ARC REVIEW CODE: R2012171

TO: Chairman Phillip Beard
ATTN TO: Kim Wolfe, City Clerk/Planner
FROM: Douglas R. Hooker, Executive Director
RE: Development of Regional Impact (DRI) Review

Name of Proposal: Kilburn–Gravel Springs Road (DRI #3213)

DRI SITE PLAN

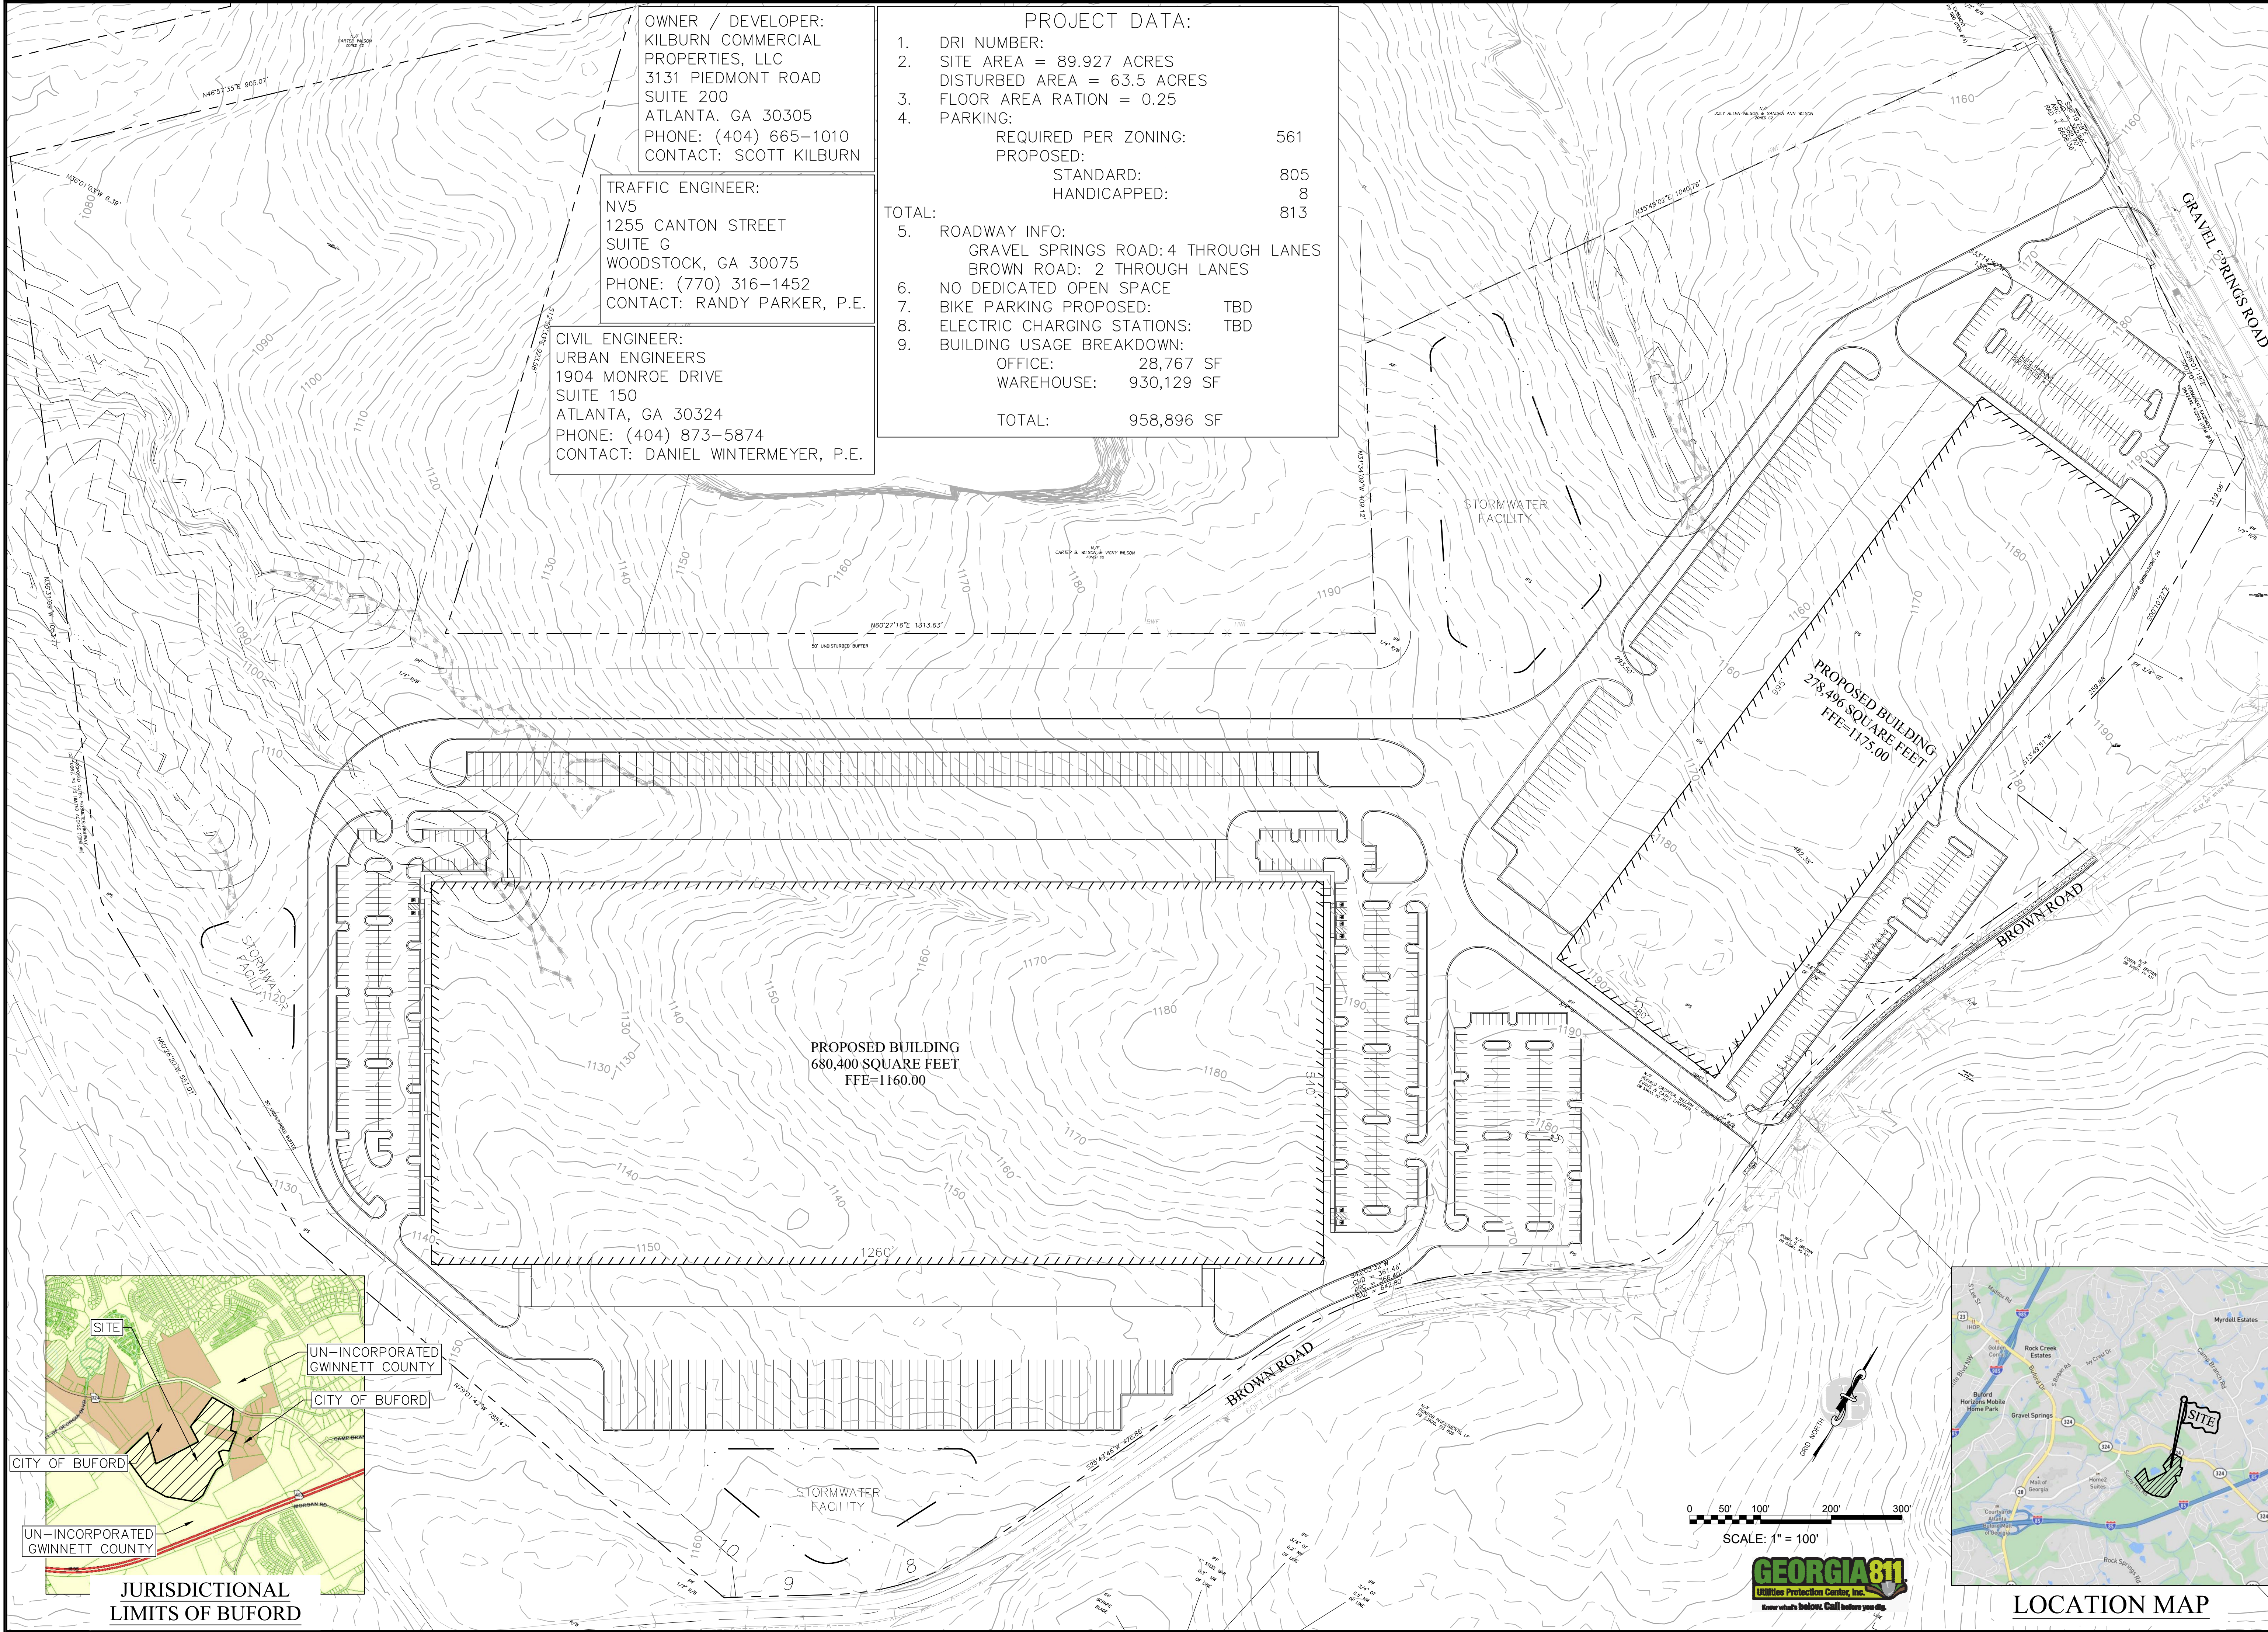
According to the site plan, there appear to be three streams in the northwest corner of the project area, plus one in the northeast corner. These are depicted with their buffers. There appears to be some encroachment of impervious

surface and building footprint area on these streams and buffers. Possible regulatory remedies for these encroachments are addressed in the Natural Resources Group Comments.

There will be approximately 40% of impervious surface coverage of the site once the project is completed. According to the site plan there are three stormwater facilities proposed for this development.

The USGS coverage for the project area does not show any blue line streams on or near the property. The project site plan shows three streams starting within the property and flowing towards the north and northwest. All three streams show 50-foot stream buffers and 75-foot impervious setbacks that appear to be consistent with the City of Buford's stream buffer ordinance, as well as the 25-foot State Sediment and Erosion Control buffer. The site plan shows a proposed driveway crossing the buffers at the headwaters of the easternmost stream and portions the entrance to truck bays, a parking lot and part of one building over a portion of one of the streams on the west side of the property. This construction may require a variance under the City's stream buffer ordinance and the State's Sediment and Erosion Control ordinance. Any unmapped streams on the property may be subject to the City's stream buffer ordinance, and all waters of the state on the property are subject to the State 25-foot Sediment and Erosion Control buffer.
